April 6, 2023

Dutchess Avenue (Grid #6158-17-198119) – Terra Group 201 LLC (Owner and Applicant) – Christopher Lapine, P.E., LEED AP, LaBella Associates (Engineer) - Site Plan.

Re: Dutchess Ave and Garden St, 2nd Review
Tax ID#: 135601-6158-17-198119
JRFA Job #06120219

1 GRADING & DRAINAGE PLAN
C140 SCALE: 1" = 20'

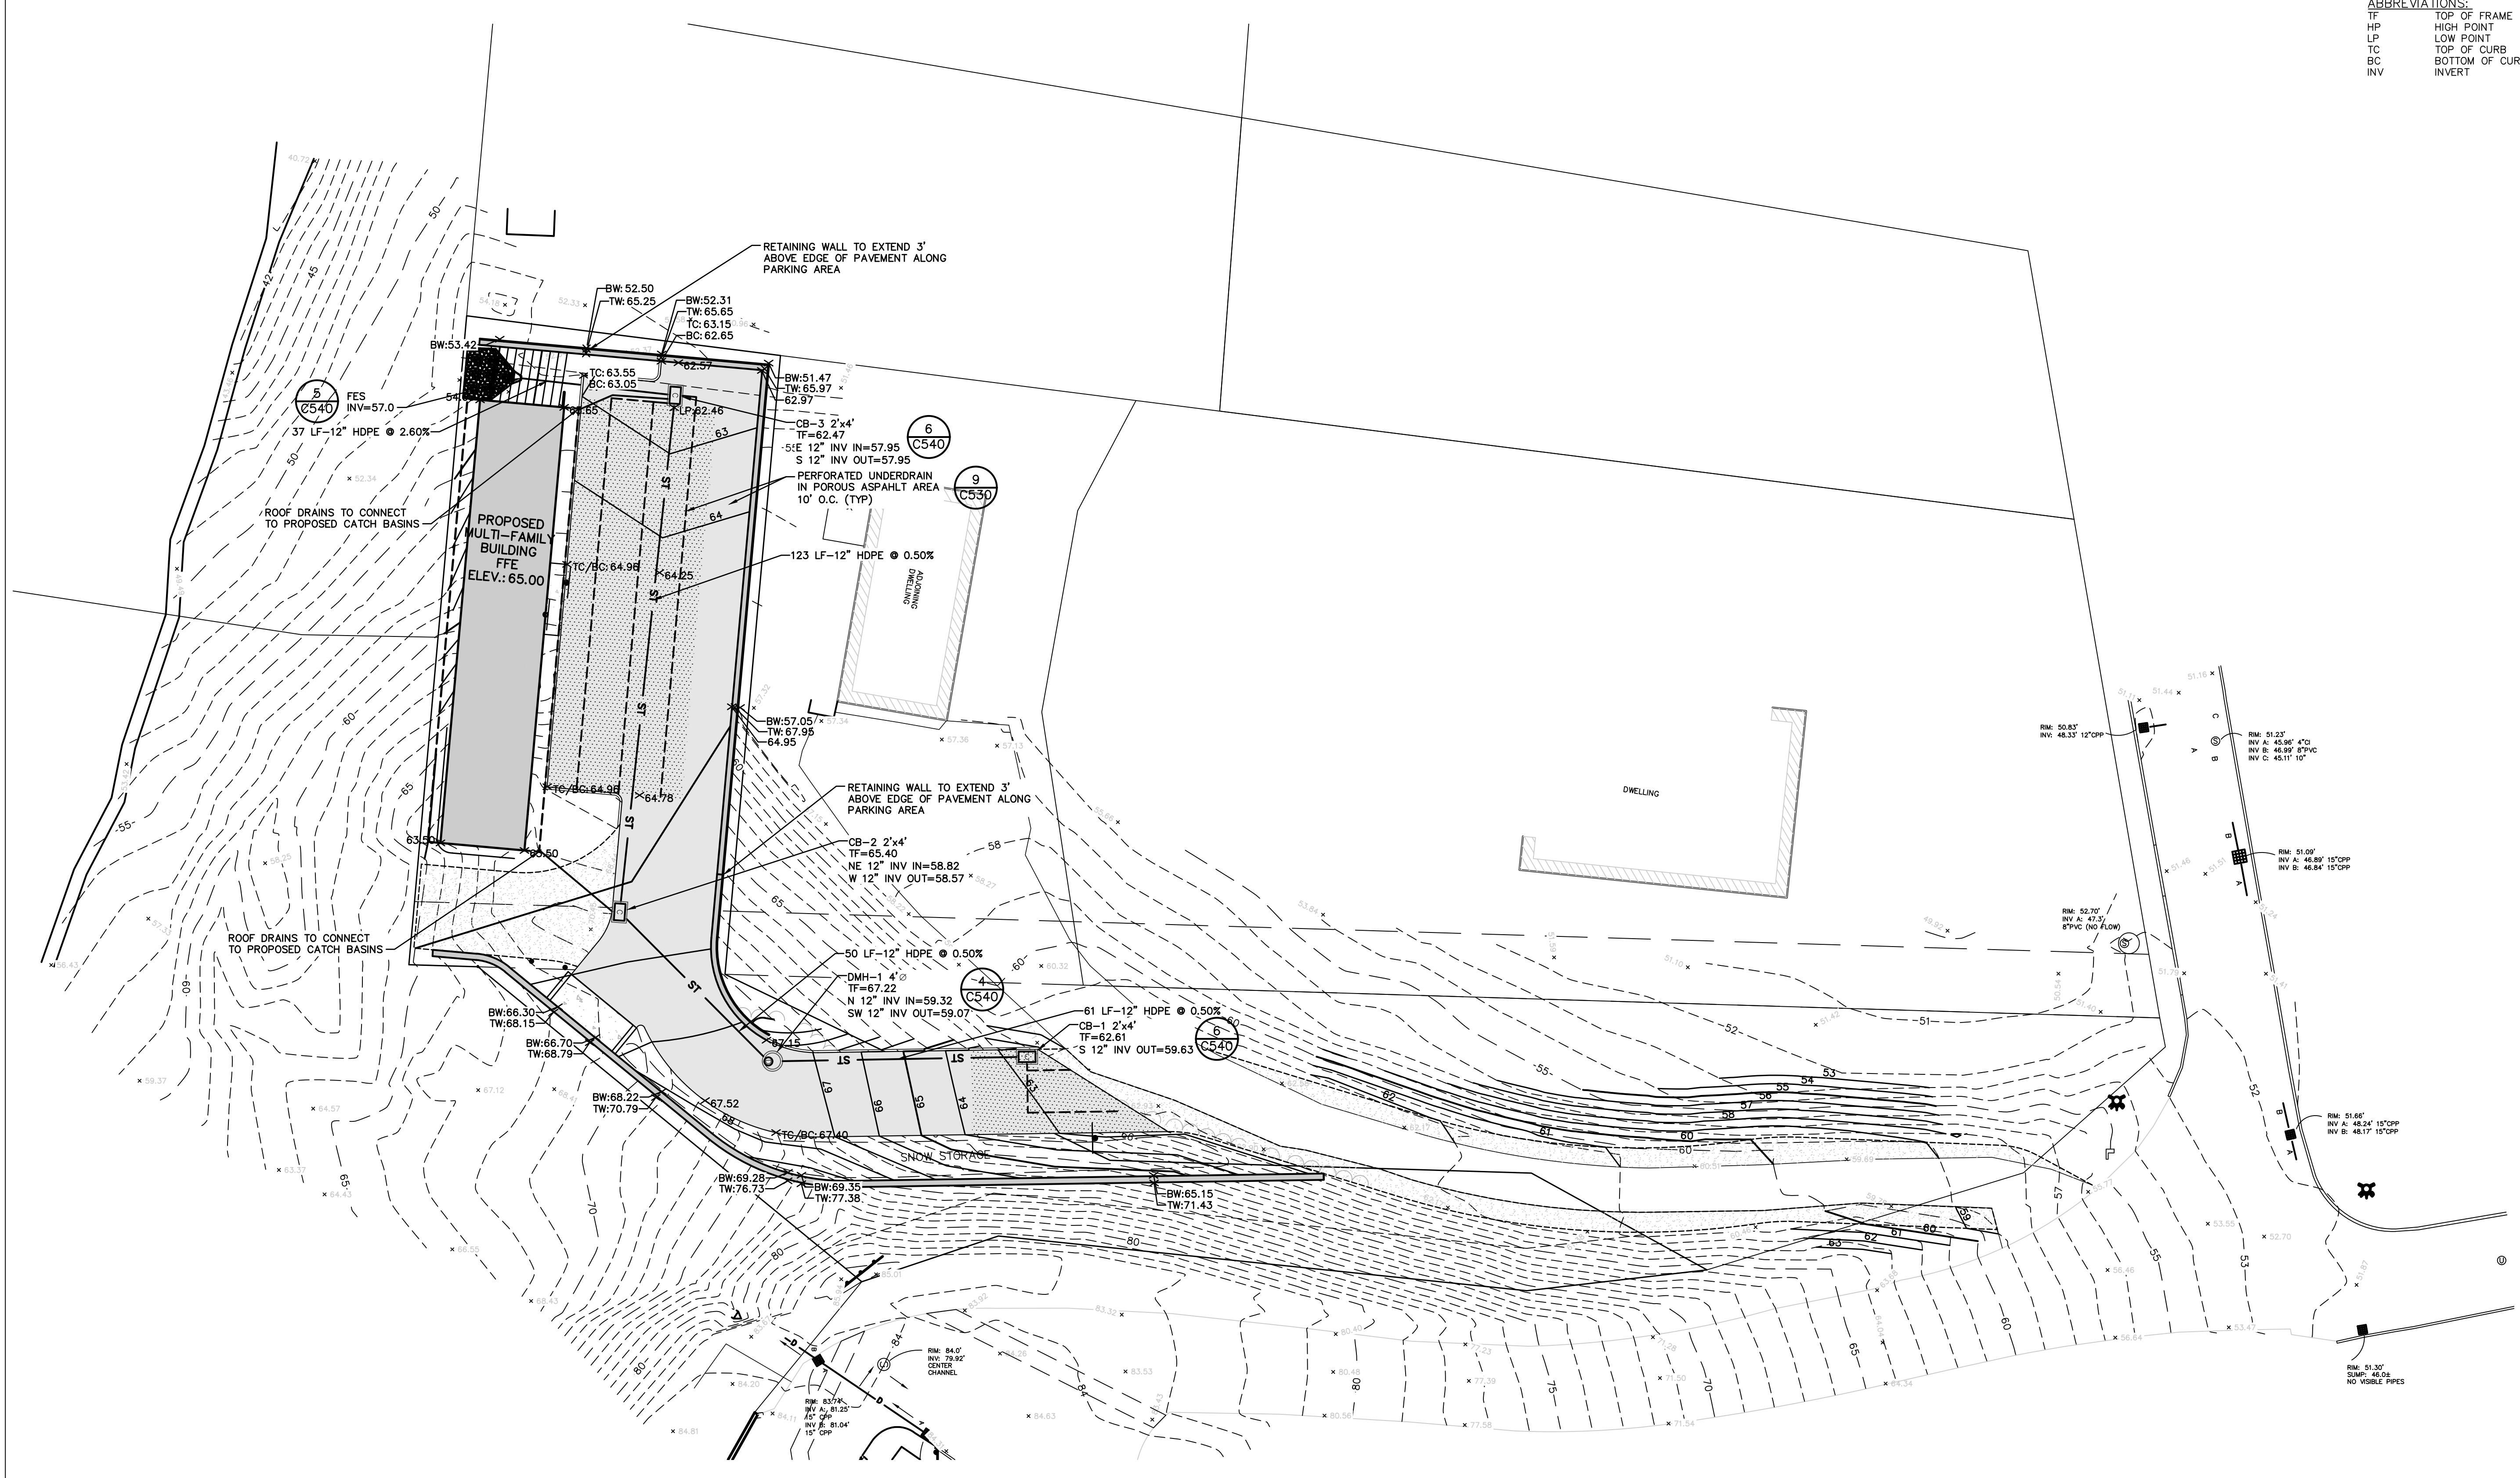
10. Applicant should provide guide rail along driveway at proposed 1 in 2 fill slope.

Response: This has been added to the plans.

SEQUENCE OF CONSTRUCTION

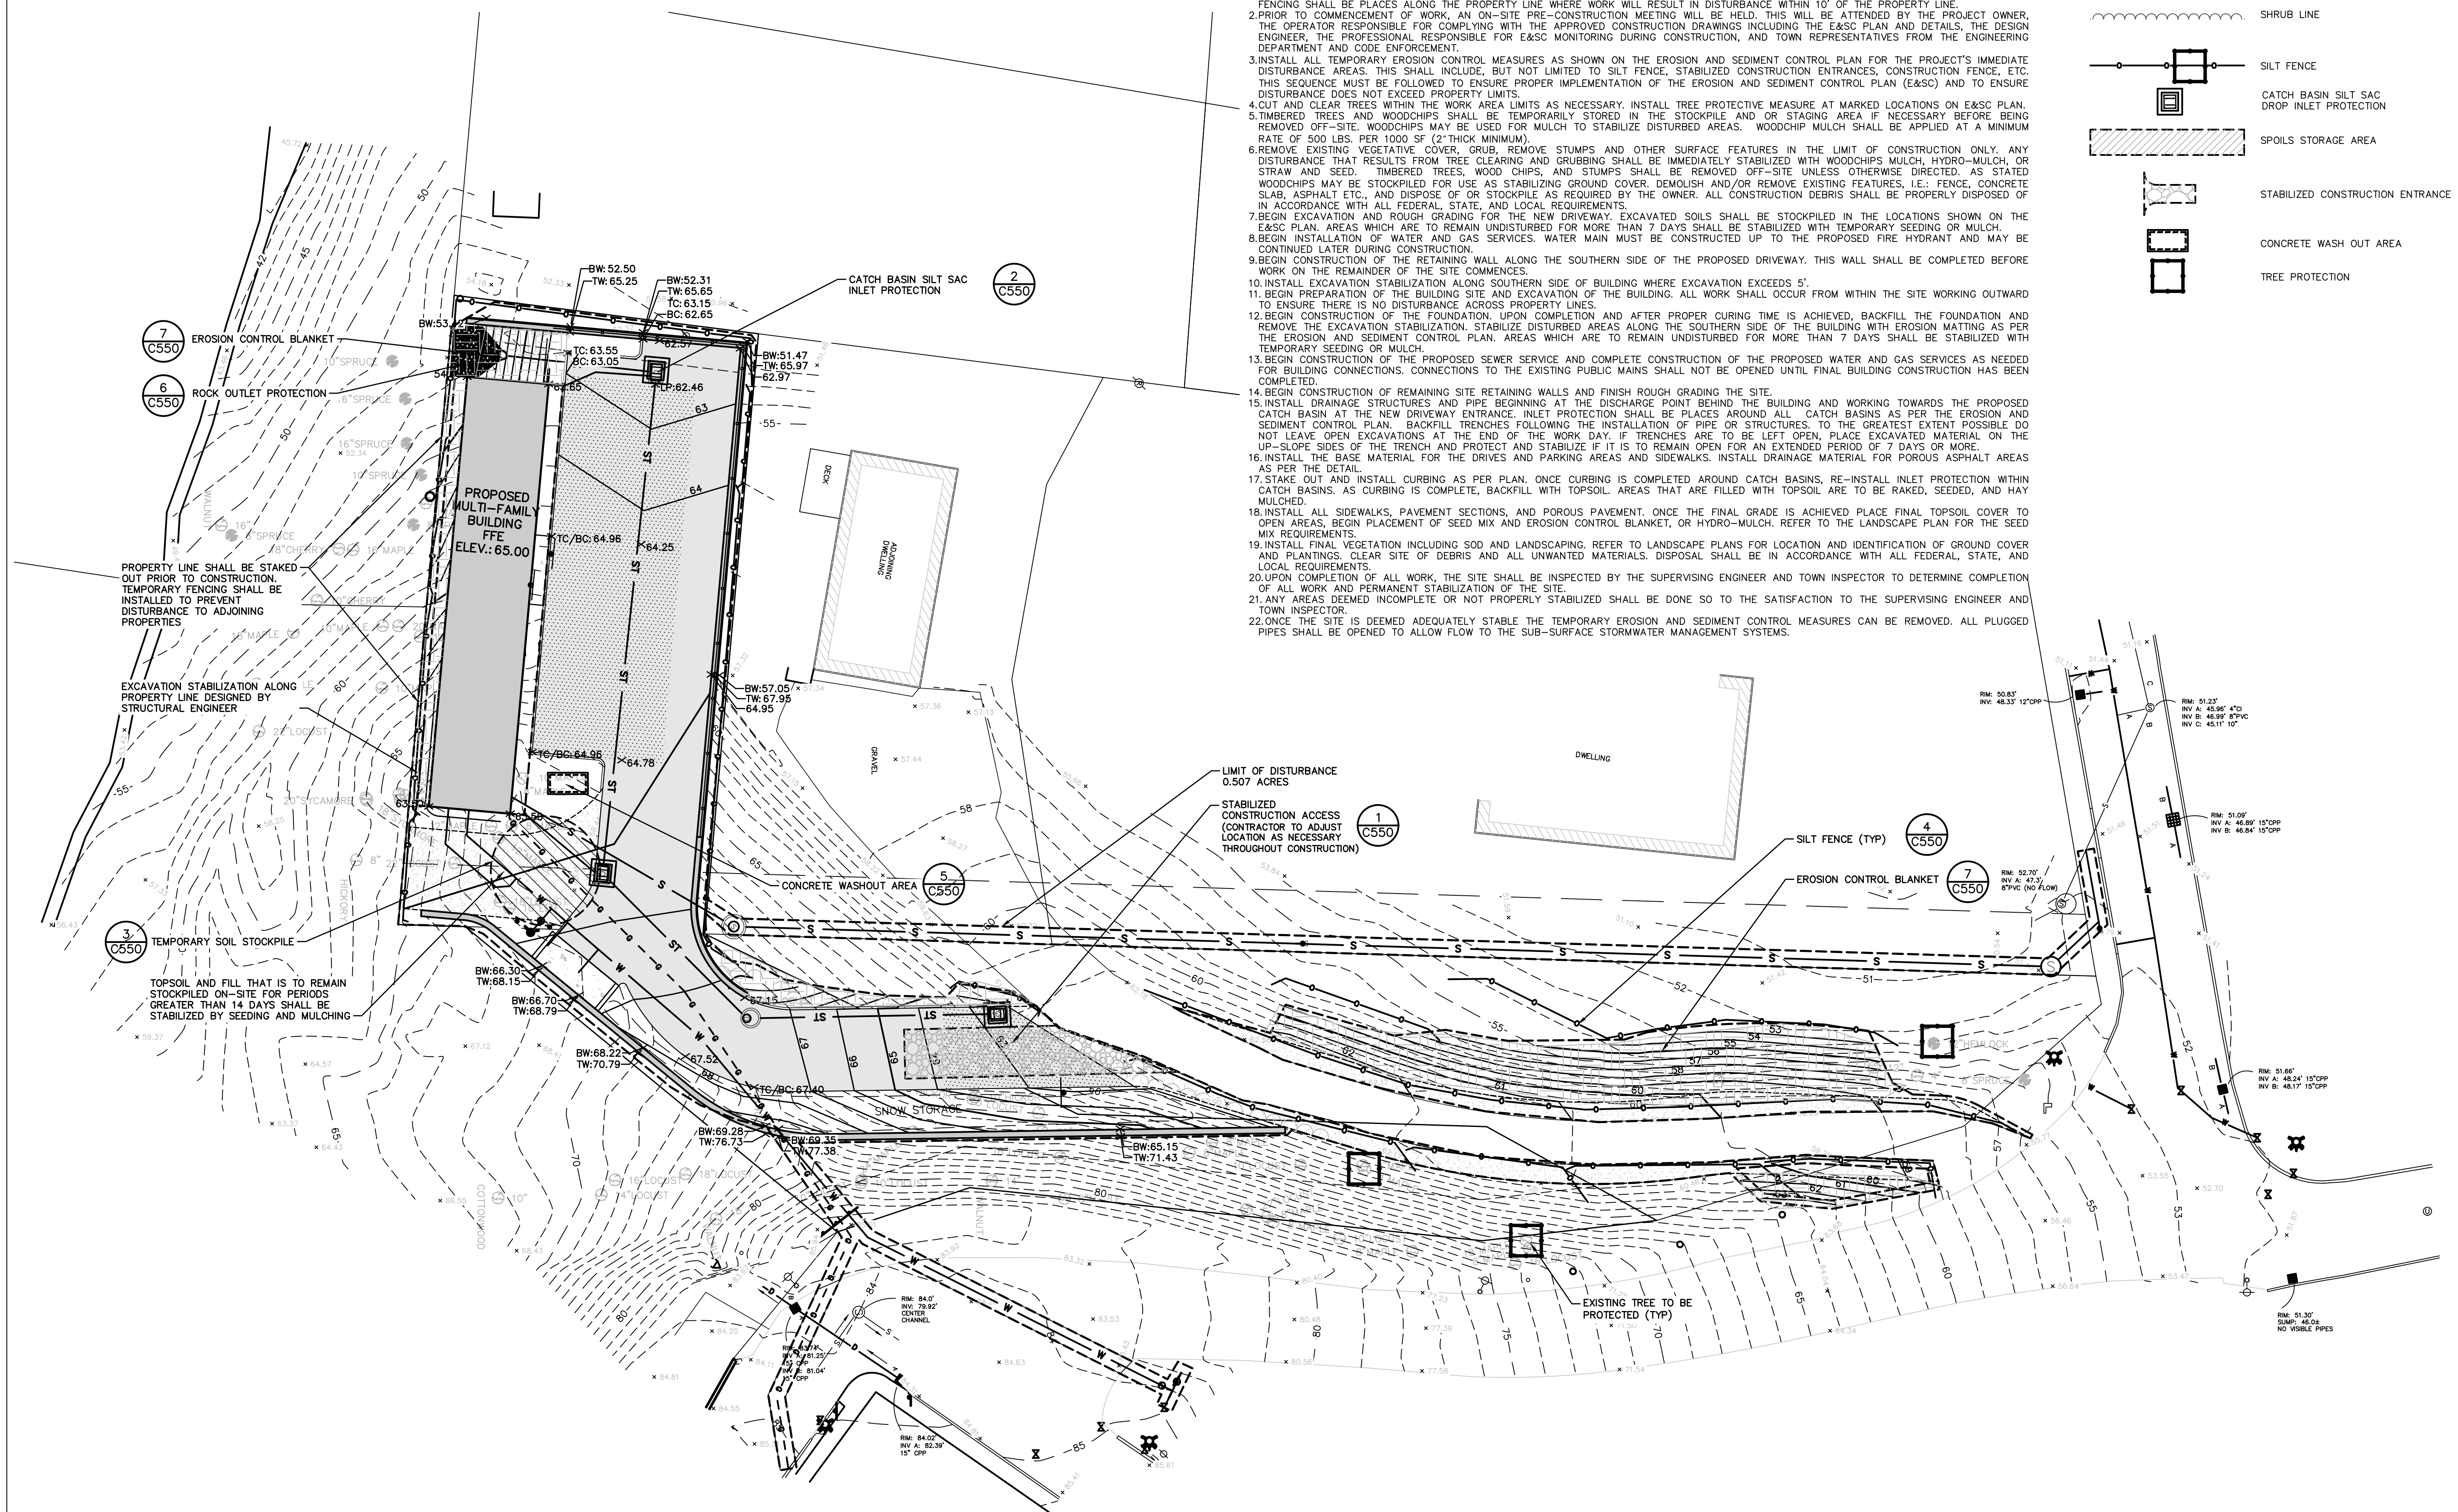
6. Construction of the building foundation and retaining walls are proposed in close to multiple property lines. Retaining wall and building footings may potentially exceed the property limits. An engineering plan demonstrating how the building foundation and retaining walls will be installed without disturbing the neighboring properties should be provided. Engineering plans should include a discussion of construction easements required from neighboring properties. Proof that the neighboring properties are agreeable to construction easements should be provided.

8. Provide an estimated project construction schedule.

Response: Construction will be performed working from the inside working out. A construction sequence has been provided on sheet C150 that illustrates how this will be done. No construction easements are planned to be need for this project.

Response: No construction easements are proposed for this project. Site improvements will be construction from the interior to prevent disturbance to adjacent properties. A construction sequence has been provided on sheet C150 that provides the method of construction.

Response: A construction sequence has been provided on sheet C150 that provides the method of construction.

LANDSCAPING PLAN

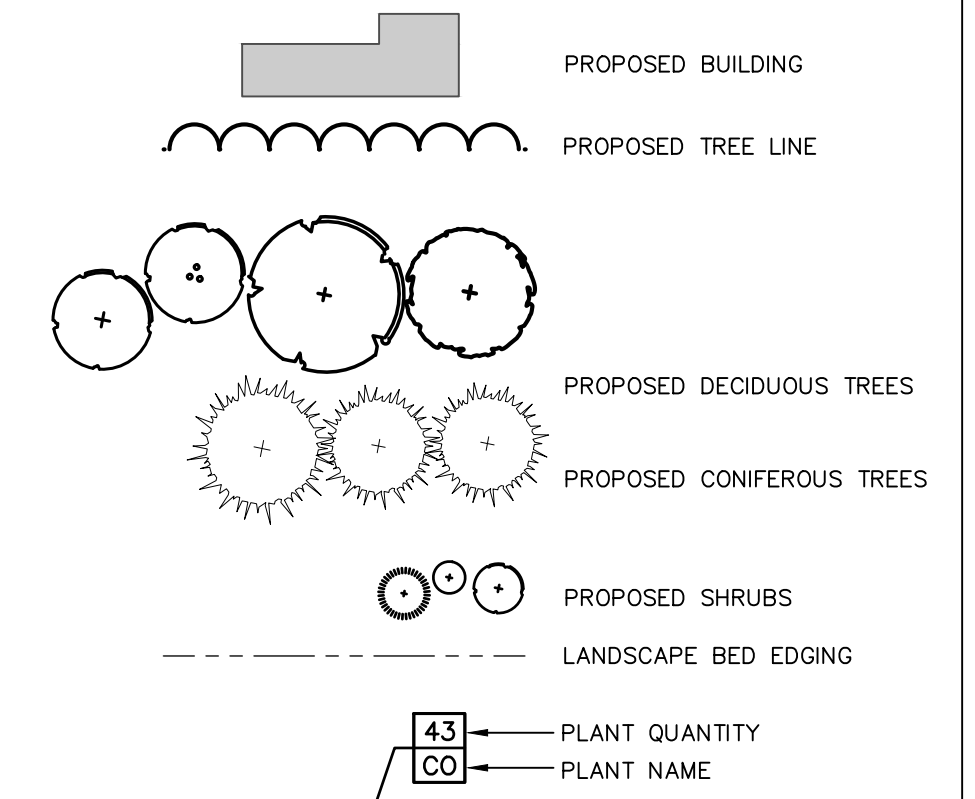
(a) Sections 151-24I(1) and (2) of the Zoning Law require that buffer plantings be installed between the parking lot and adjacent properties, and between the parking lot and the street. Buffer planting is defined as “an area intended to provide an effective year-round visual barrier between different land uses and to protect against noises, odor, dust, flare and unsightly storage.” The “Miss Kim” Lilac proposed for the buffer between the properties to the north and west is a very slow growing deciduous shrub that will reach a height of 4 feet to 7 feet. It will not provide a year-round visual barrier.

(b) A landscape maintenance note should be added to Sheet C180 stating, “The owner of record shall maintain all landscaping as shown on the Site Plan throughout the duration of the use.”

a.) The landscape plan has been revised to incorporate evergreen species along the face of the wall.

b.) This note has been added to the Landscape Plan
